**TOWN OF HERNDON, VIRGINIA
ARCHITECTURAL REVIEW BOARD
VIRTUAL PUBLIC HEARING AGENDA
DECEMBER 16, 2020
HERNDON COUNCIL CHAMBERS BUILDING
765 LYNN STREET
7:30 P.M.**

Subject: ARB #20-026, 365 Elden Street, Outback Steakhouse New Construction Update

**Re: ARB Application for Freestanding Sign Permit, ARB #20-028
Elden Street Marketplace, 1025 Herndon Parkway, Herndon, VA 20170**

**Re: ARB Application for Wall Sign Permit, ARB #20-029
Elden Street Marketplace, 1025 Herndon Parkway, Herndon, VA 20170**

MOUNTING ELEVATION
1/8" = 1'-0"

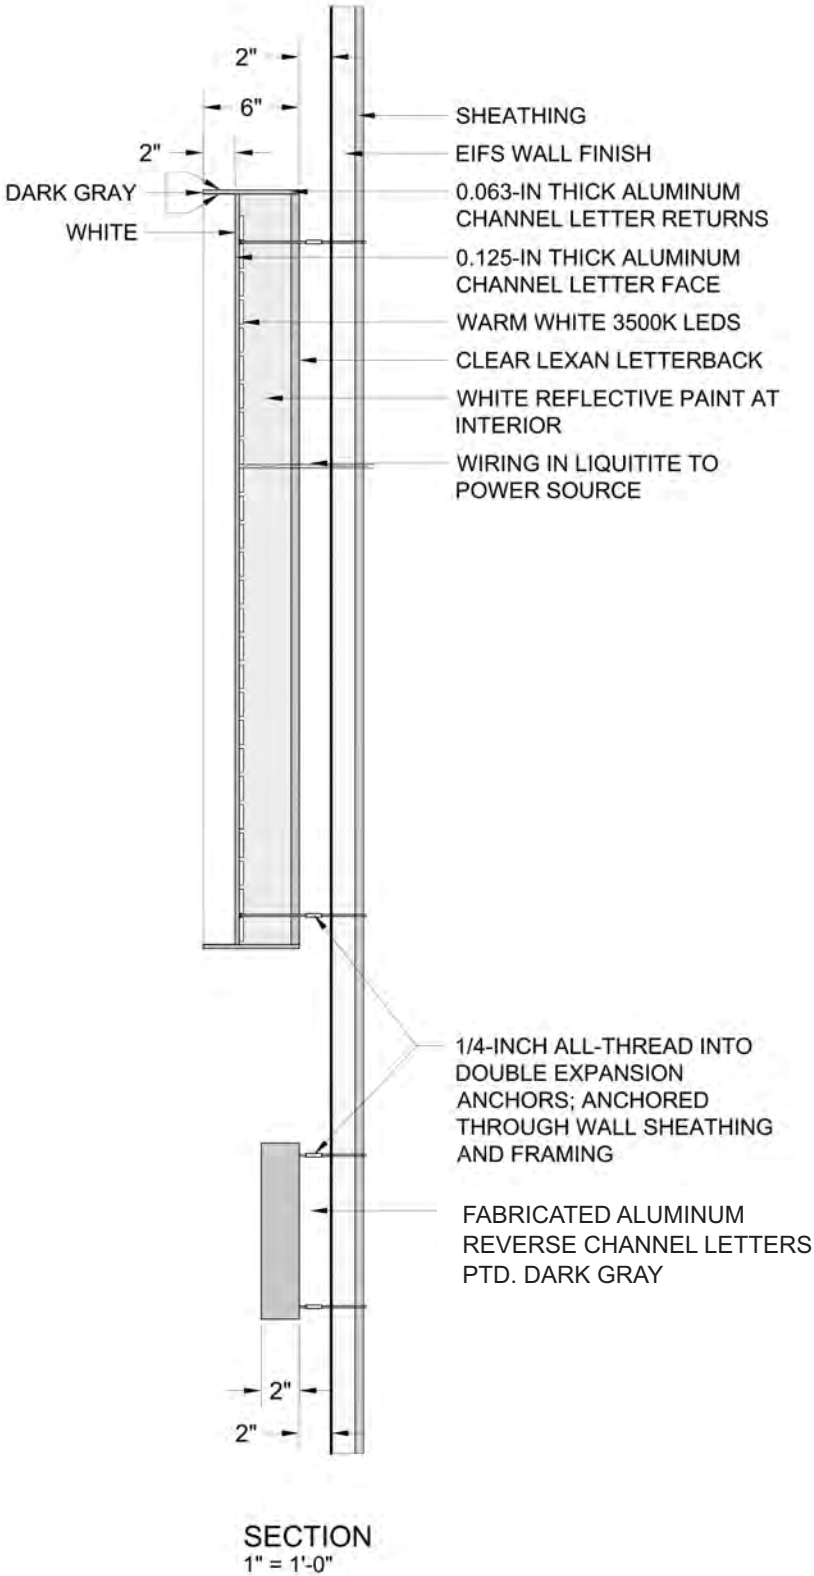
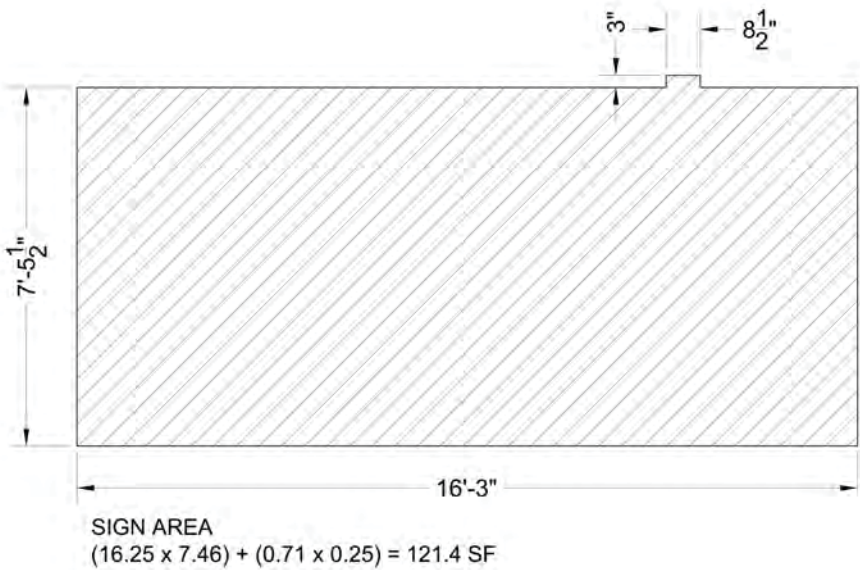
“...staff recommends that the Marketplace lettering be made of a higher quality material, metal to be specific, and be finished in the same manner as the illuminated reverse channel letters of the Elden Street sign component..”

The enclosed submission has adjusted the material used for the Marketplace lettering to aluminum with a finish to match the returns of the Elden St. portion of the sign.
